Review of Conservatism in the Seabrook Consequence Analysis

Technical Review April 25, 2014

Figure 1. Effect of deposition velocity on deposition at distances up to 80 km from the release location.

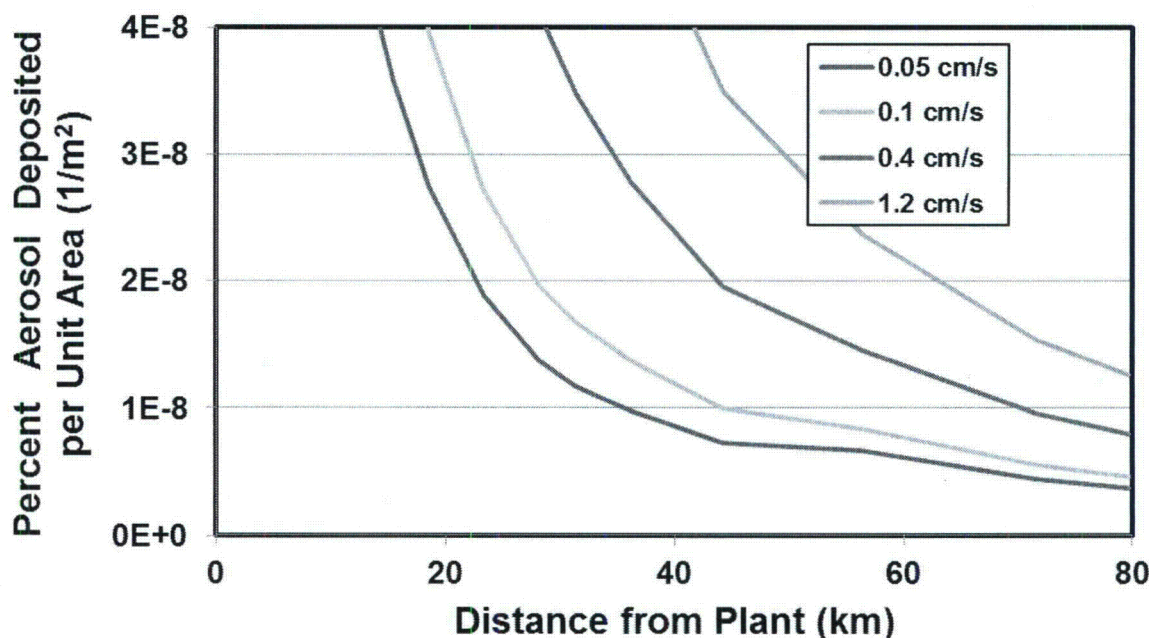
Dry Deposition Velocities (VDEPOS) – This parameter contains the set of dry-deposition velocities corresponding to the particle-size groups. In the SAMA analysis conducted by NextEra, one aerosol size was selected to represent the released aerosols and therefore only a single deposition velocity was used.

NextEra chose a dry deposition velocity of 1 cm/s, which corresponds to an aerosol with a 6 micrometer hydrodynamic diameter. In the State of the Art Reactor Consequence Analysis (SOARCA) study [NRC, 2012], a higher level of fidelity was used than is typically employed in a SAMA analysis: 10 aerosol sizes were used to capture the distribution of sizes predicted using a state-of-the-art model for source term and each aerosol size used its own deposition velocity. It was noted at the time of the SOARCA study that the behavior of the aerosols corresponded to a 0.3 cm/s mean deposition velocity. Further discussion of the 0.3 cm/s deposition velocity is provided in the next section. The effect of a lower deposition velocity is to reduce ground concentrations (as shown in Figure 1) and reduce the amount of land that needs to be interdicted and decontaminated. The effect of using a more realistic deposition velocity is considered in the next section.

NextEra Value: 1 cm/s
Recommended Value: 0.3 cm/s

Figure 2. Approximate surface roughness lengths (z_0) for various surfaces [DOE, 1987].

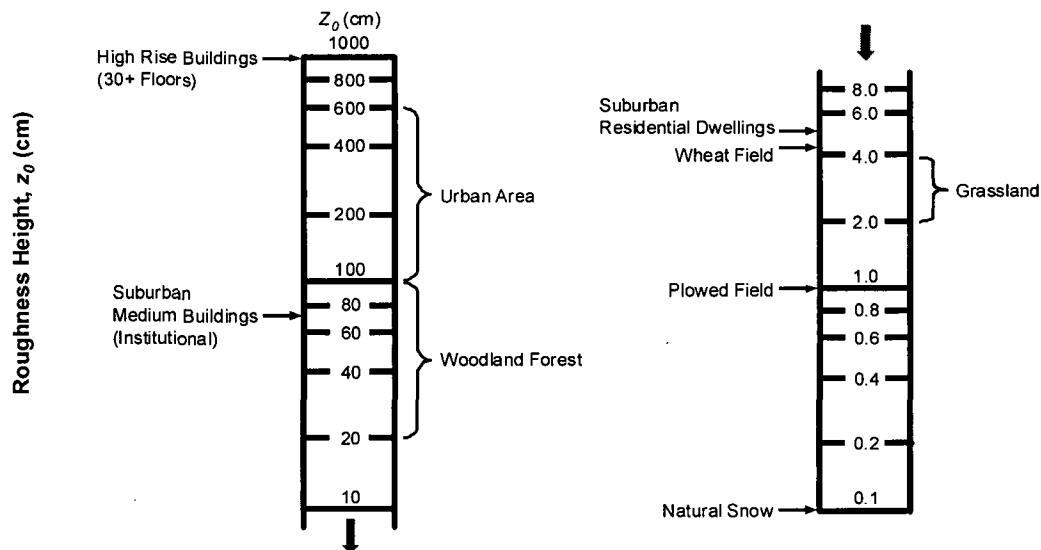
The SOARCA project [NRC, 2013a], included a sensitivity analysis for surface roughness and showed that health effects risk is affected by surface roughness. This parameter was therefore reviewed for Seabrook. NextEra selected a surface roughness value of 10 cm. The area around Seabrook consists largely of forest intermixed with suburban housing, farmland, and of course ocean. Near the southern limit of the SAMA analysis, the land use becomes more urban while the rest of the outer limits of the SAMA area are largely forested and suburban. It is the inland area that is of interest in the SAMA analysis, because this is the area within which costs are accounted; therefore, the surface roughness does not need to include consideration of the ocean. As indicated in Figure 2, the inland mixture of land use better corresponds to a surface roughness value between 20 and 100 cm, making the value of 10 cm selected by NextEra conservative. To estimate the conservatism in surface roughness, Sandia chose a value of 50 cm to better represent this diverse land area.

Surface roughness is not an input parameter to MACCS2, but influences two parameters that are used as input. The first is the scale factor for vertical dispersion (ZSCALE, which is discussed in the next paragraph) and the second is the deposition velocity, which was discussed in the previous paragraphs. The effect of increasing surface roughness in NUREG/CR-7110 Vol. 1 [NRC, 2013a] is that health effect risk is decreased. It should have a similar effect on OCR in a SAMA analysis.

NextEra Value: 10 cm
Recommended Value: 50 cm
